# **Proposal on Drafting Hydrogen Storage System Part of the HF CV-gtr**

**3 JUL, 2009**

**JASIC**

SGS 6-03 draft

## Proposal for the 5.2.2.2(Hydraulic Cycle Sequential Test)

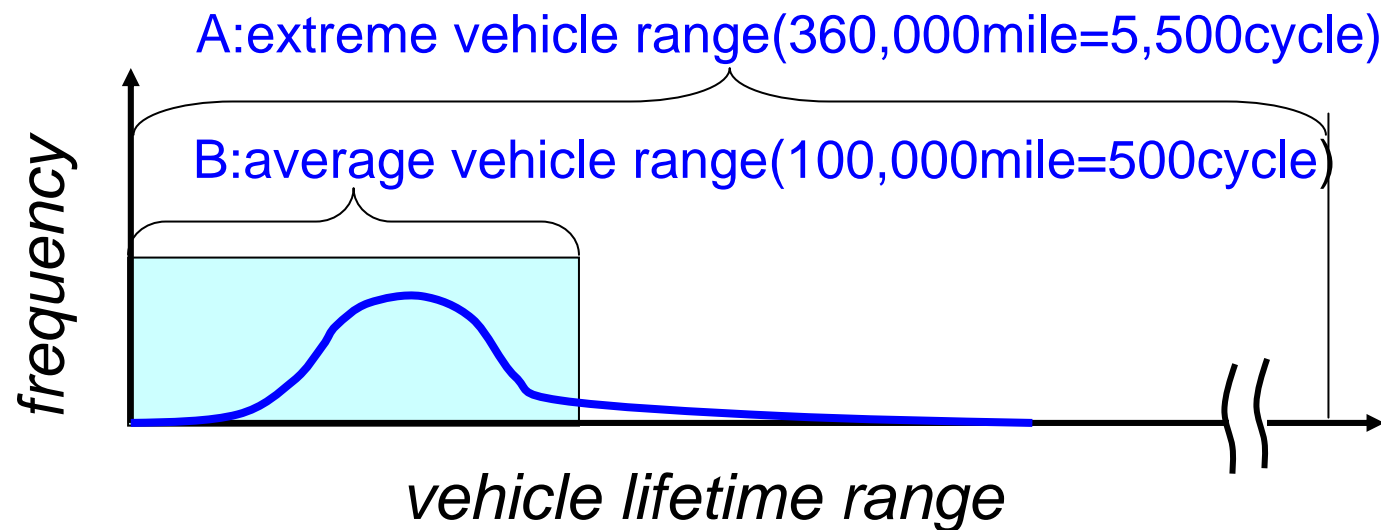
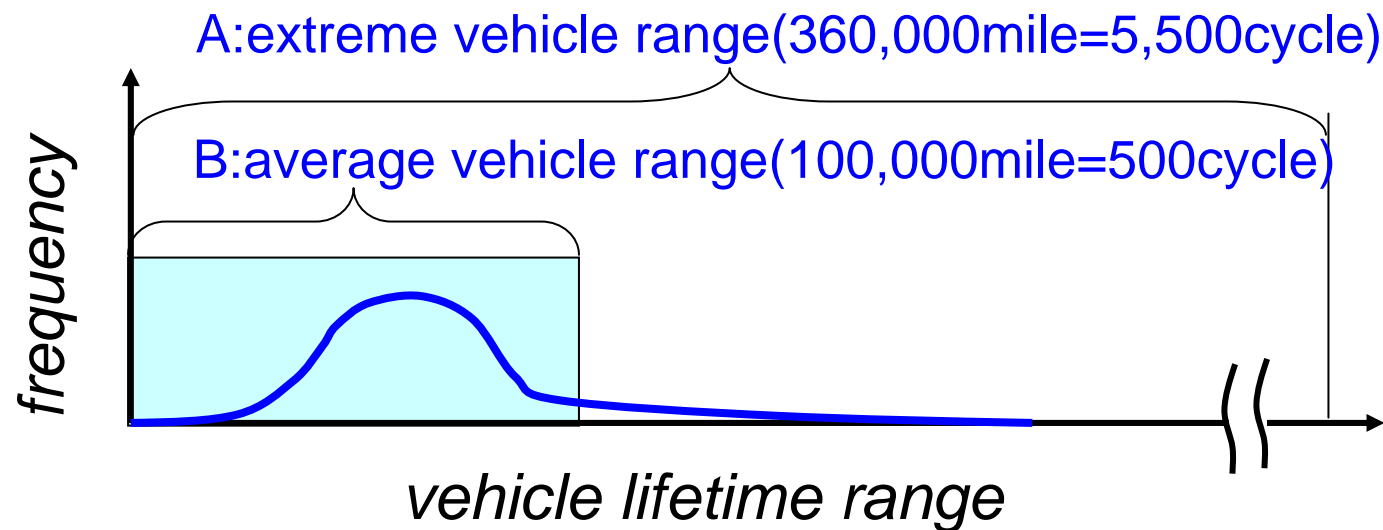
/JASIC propose to change the 5.2.2.2.

/ JASIC think hydraulic test(5,500cy) with extreme temperature condition is appropriate to validate the safety at end of life(15 years, extreme vehicle range). *(The hydraulic cycle test will be severer condition than pneumatic test as a result of stress analysis, please find APPENDIX. )*

/On the other hand ,the pneumatic cycle test (500cy) and hydraulic test with room temperature is not enough to validate the end of life safety.

/Pneumatic cycle test(100,000mile=500cycle) is appropriate to validate the fails which could not be validated by hydraulic test.

SGS 6-03 draft	proposal	comment
<b>5.2.2.2</b>	Hydraulic Cycle Sequential Test (5,500cy) -room temperature	1)Hydraulic Cycle Sequential Test (5,500cy) -extreme temperature 2) Add static pressure test of 1000hr and 85C.	Hydraulic test(5,500cy) with extreme temperature and static pressure test (1000hr,85c)shall be to validate the safety at end of life(15 years, extreme vehicle range)

Proposed 5.2.2.2 test condition

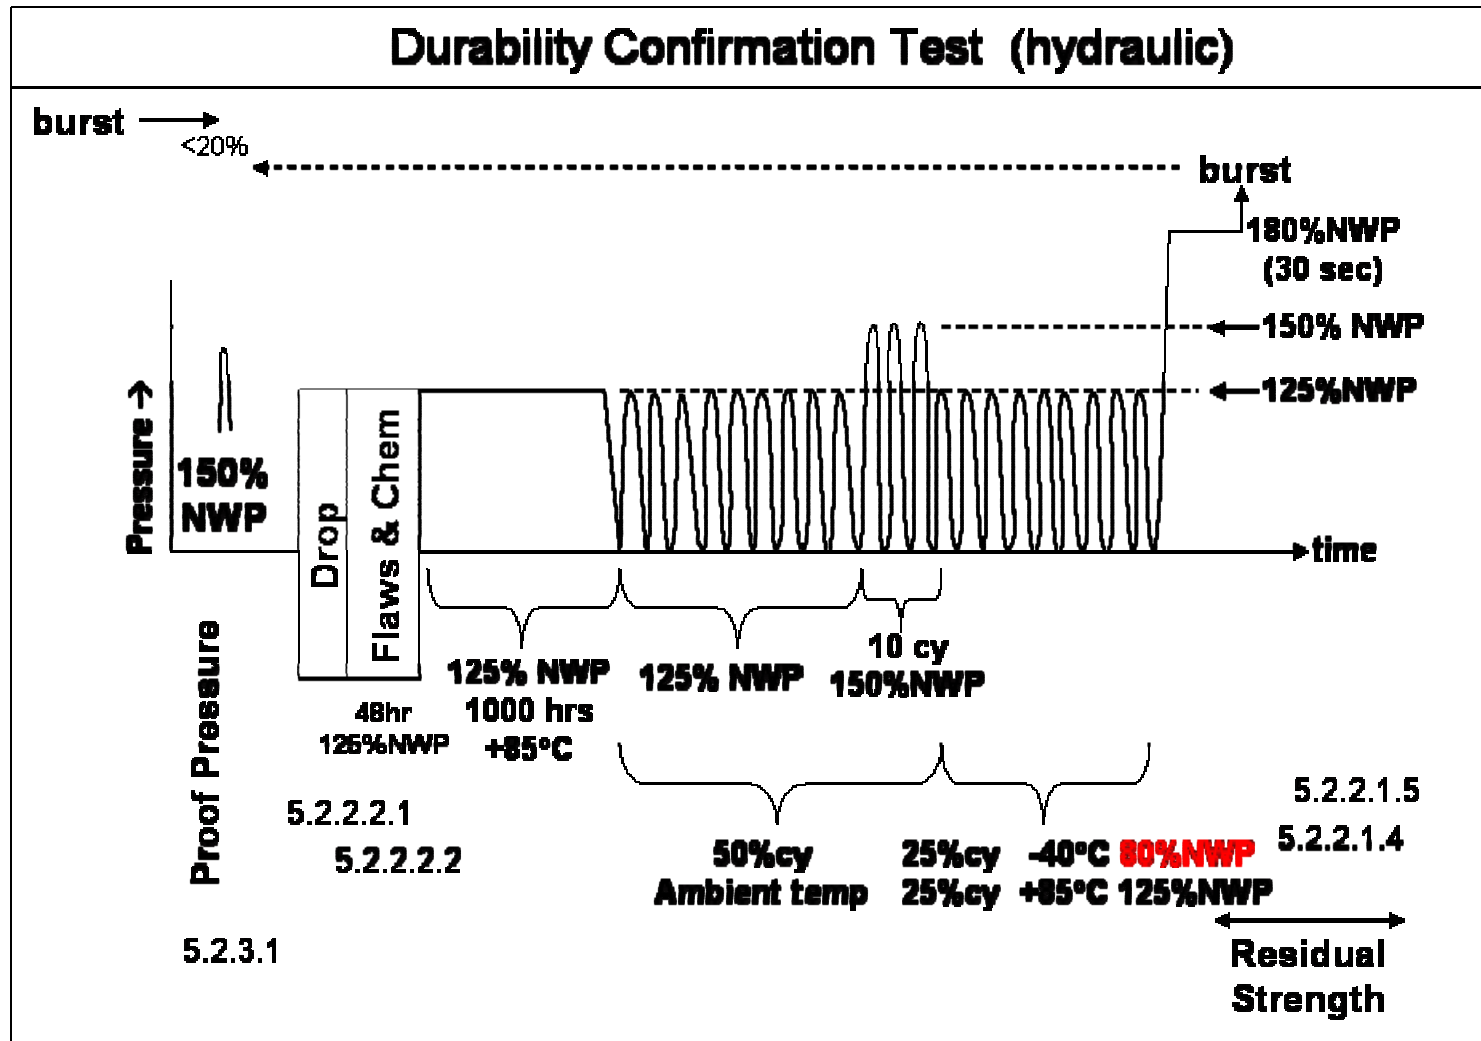
# Proposal for the 5.2.2.2 (Hydraulic Cycle Sequential Test)

## **Proposal for the 5.2.2.1** (Pneumatic Cycle Sequential Test)

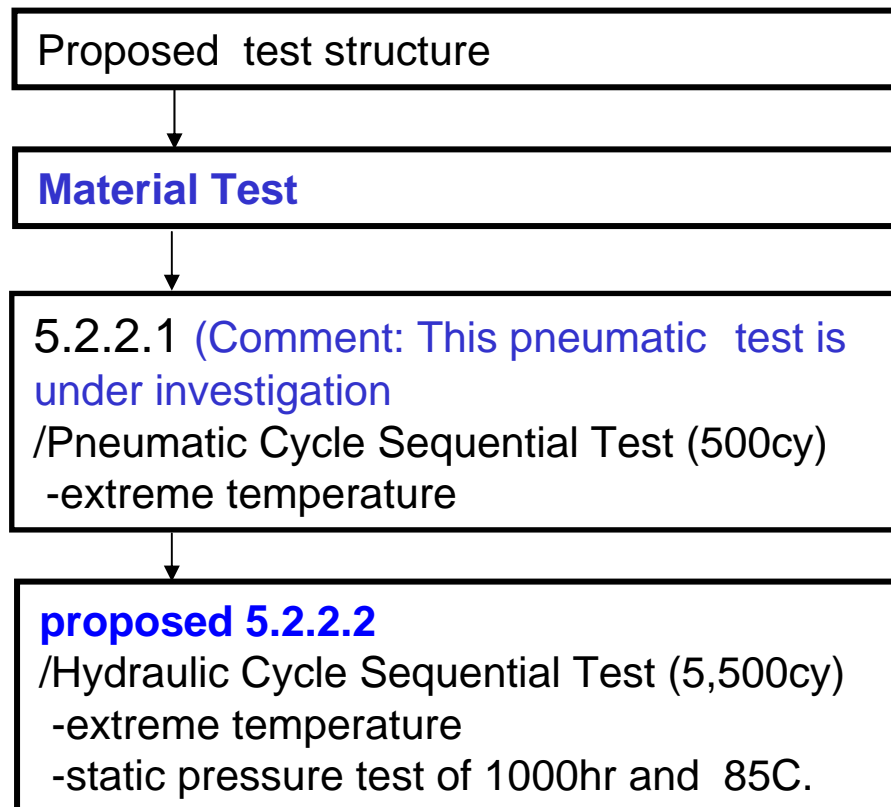
(Comment: This pneumatic test is under investigation. The test condition of temperature and cycle number should be discussed.)

Expected Service (Pneumatic) Performance Test applies to the non-metal liner containers.

If alternative test is technically effective for the failure, manufactures can select the alternative test instead of the pneumatic test.

Fig.2 stress of Aluminum liner

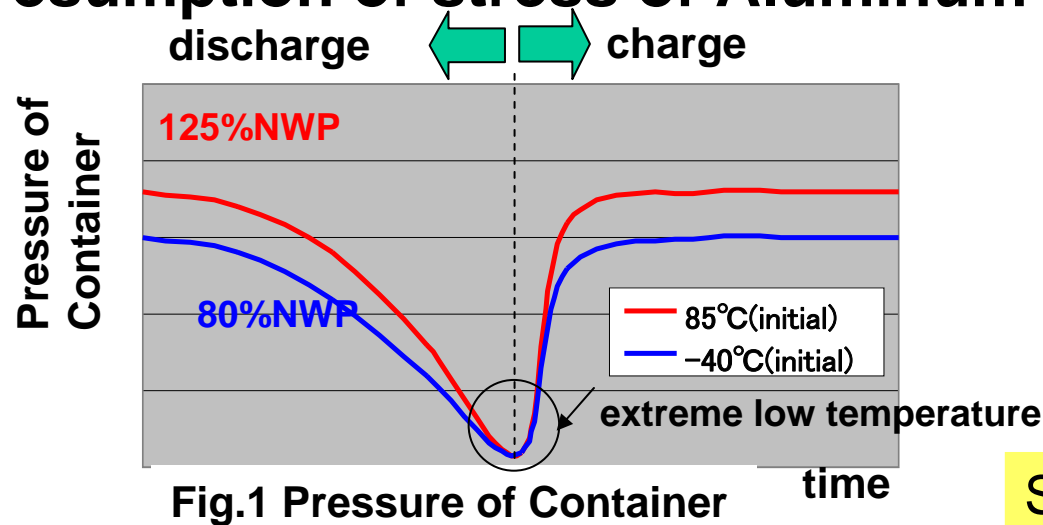
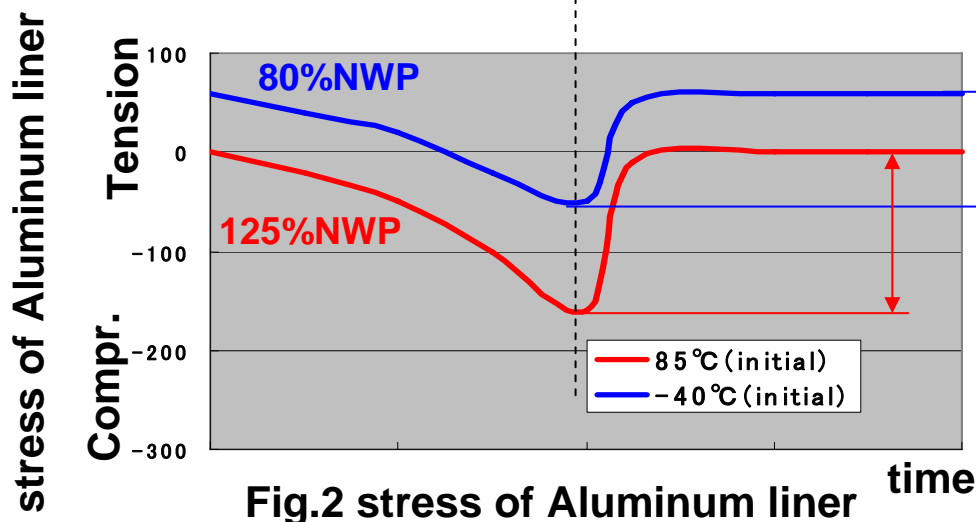
The temperature at the end of discharge shows extreme low, but stress range of low temperature condition is smaller than high temperature.

Stress range of low temperature condition is smaller than high temperature due to decrease of pressure and Aluminum liner's contraction.

Fig. 3 stress change by temperature

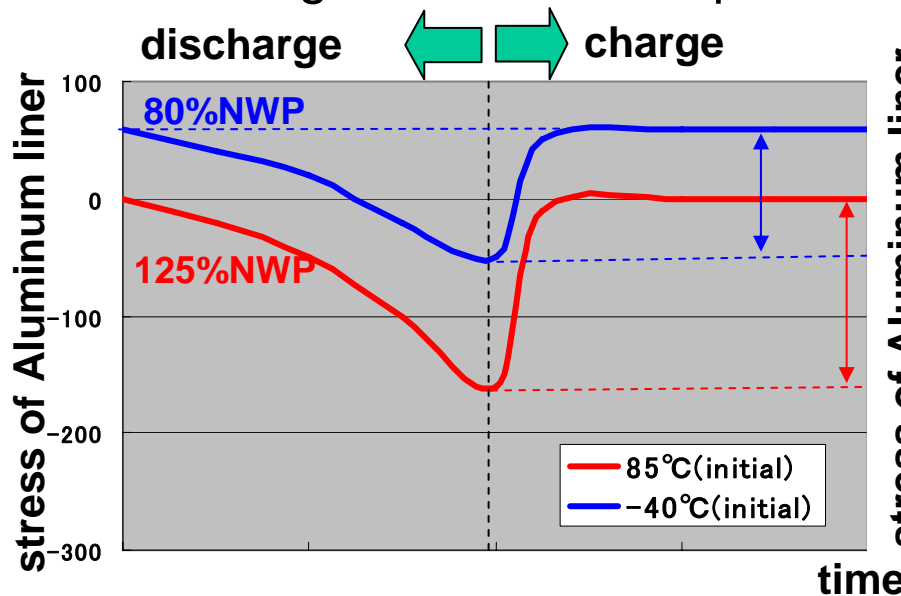
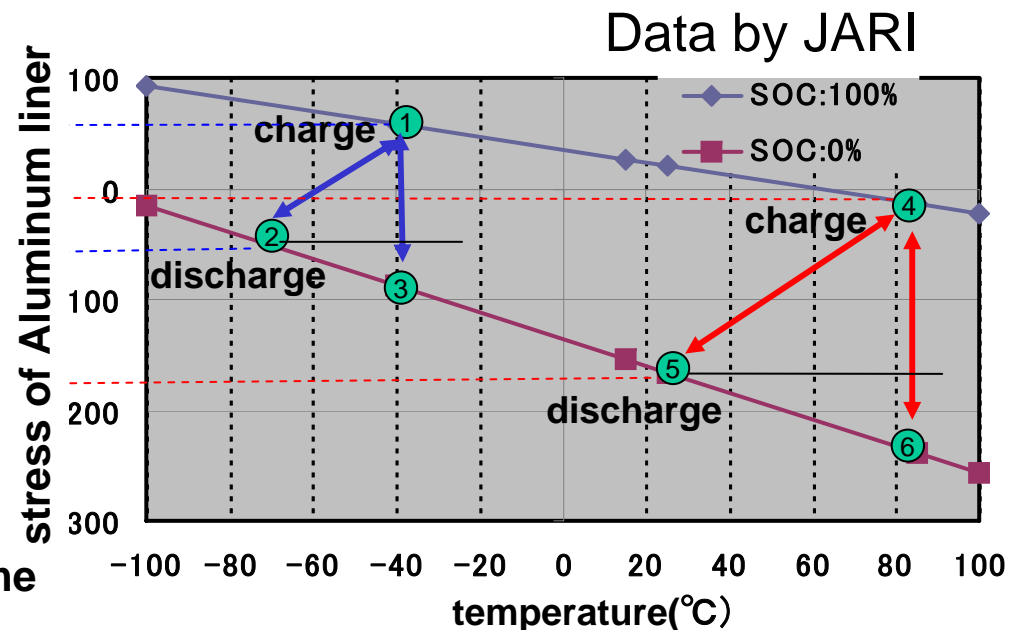
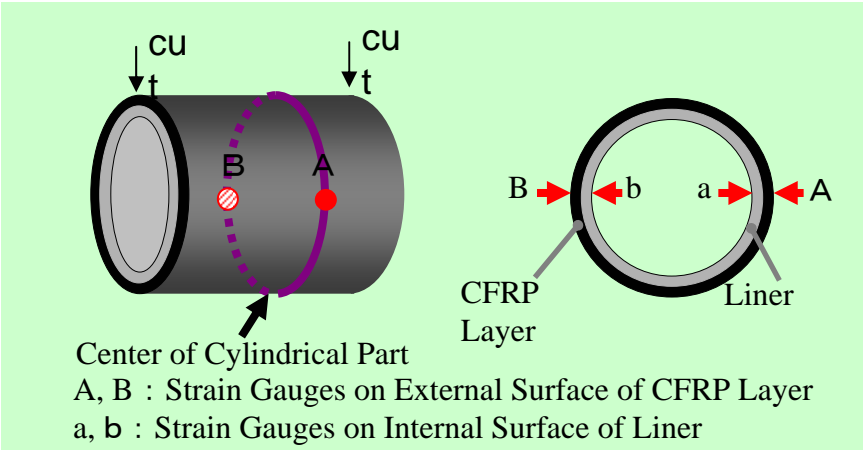
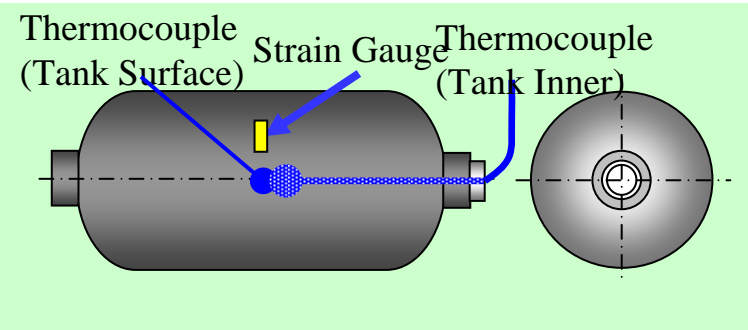
The stress of aluminum liner by cycle test (pneumatic) at -40C will change between ① and ② in Fig.3. The liner stress of hydraulic cycle test at -40C change between ① and ③. Similar to ④ ⑤ ⑥ at 85C.

The hydraulic cycle test will be severe condition because of large stress range. So JASIC think the hydraulic pressure cycling test can simulate the pneumatic cycling test.

JASIC will conduct LBB test and confirm the container life depend on stress range but not on temperature.
